RE: Docket No. 317 Regarding UI Trumbull Substation Application

**The Connecticut Energy Advisory Board's
Assessment
of
The United Illuminating Company's
Proposed Trumbull Substation**

**Questions Submitted to United Illuminating
and the Response**

**Re: United Illuminating – Proposed Trumbull Substation Questions from
the Connecticut Energy Advisory Board**

UI Substations Abutting
 Trap Falls and Old Town
 Docket 317
 CEAB - 1
 Attachment 1
 7/17/06

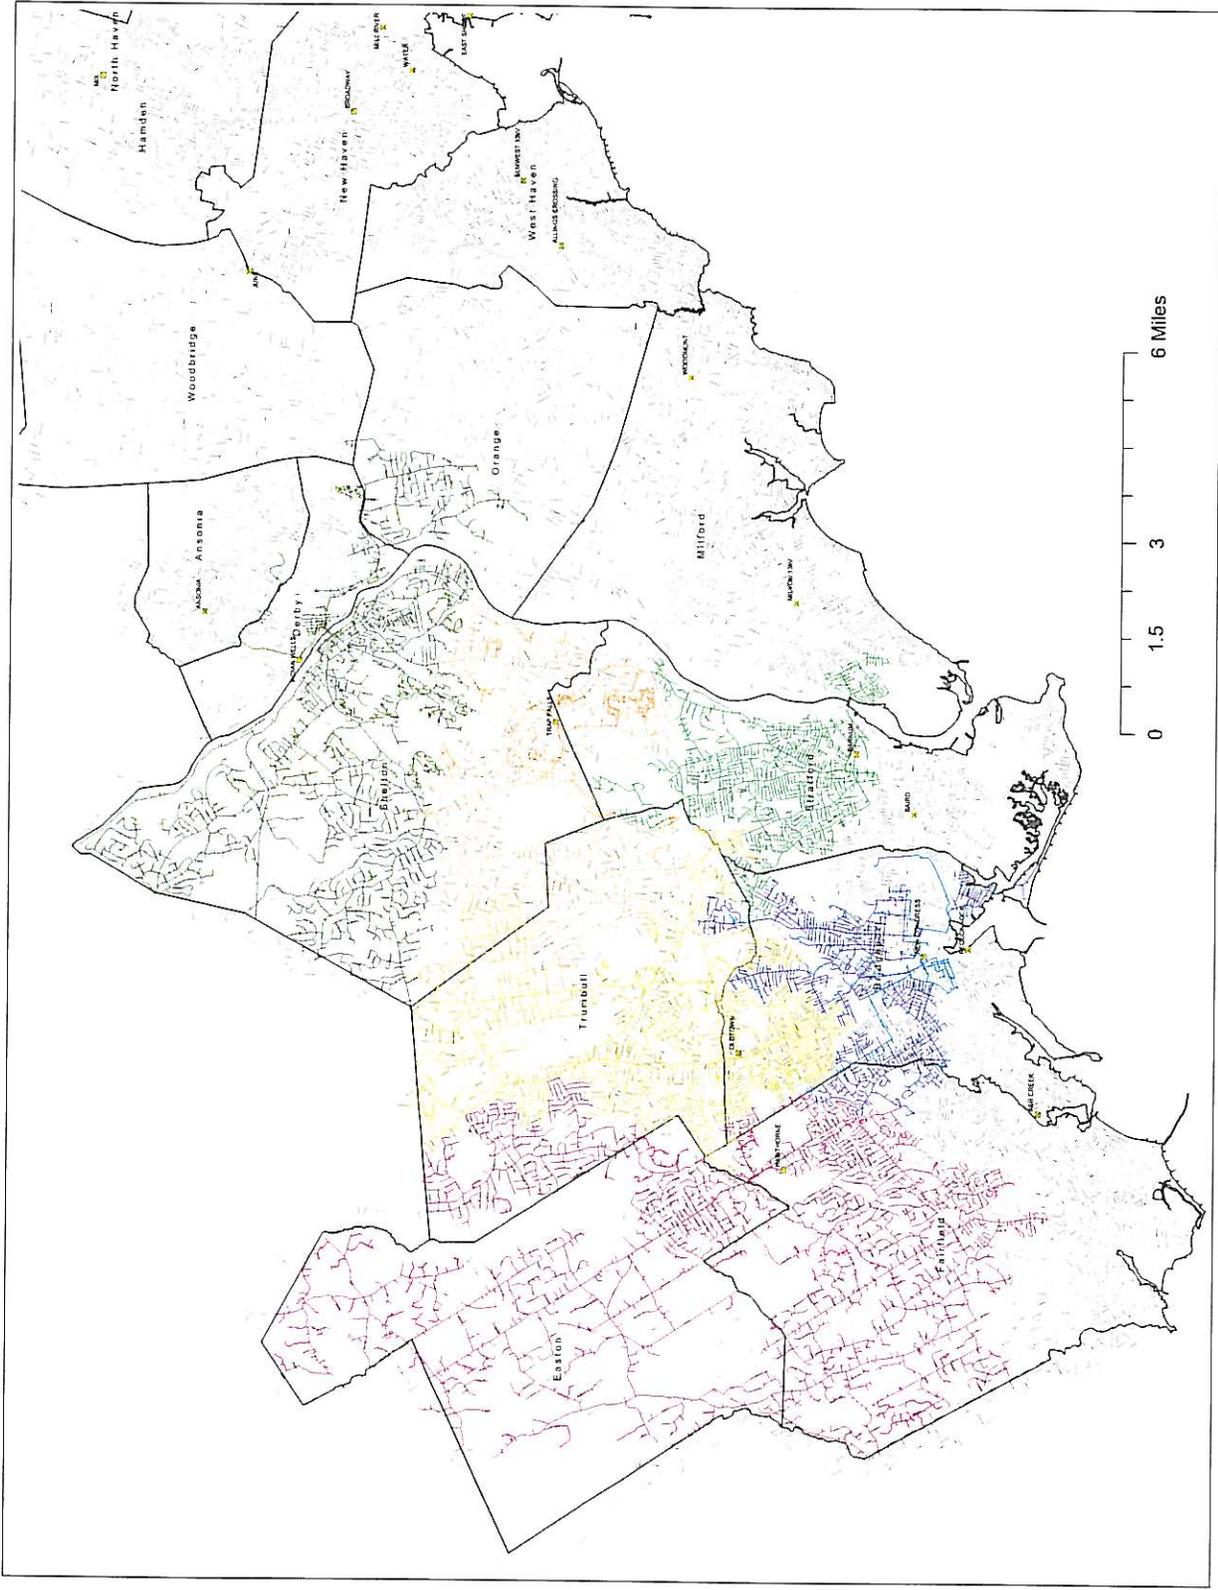
Q-CEAB-1: Please provide a list of all existing substations that serve areas that abut the area served by the Old Town and Trap Falls substations. For each substation listed above, please provide a street map showing the area served, the number and size of transformers located there, the MVA rating of the station, and the 2005 actual load in MVA. Also provide a graph similar to figure 4 and 5 on page 7 of Volume I.

A-CEAB-1: A map illustrating the areas served by substations adjacent to Trap Falls and Old Town have been included as Attachment 1

Each of UI's bulk substations is equipped with 2 transformers, the rating supplied is the firm rating of one transformer. Graphs of the abutting substation actual loads, forecasts and ratings are included as Attachment 2.
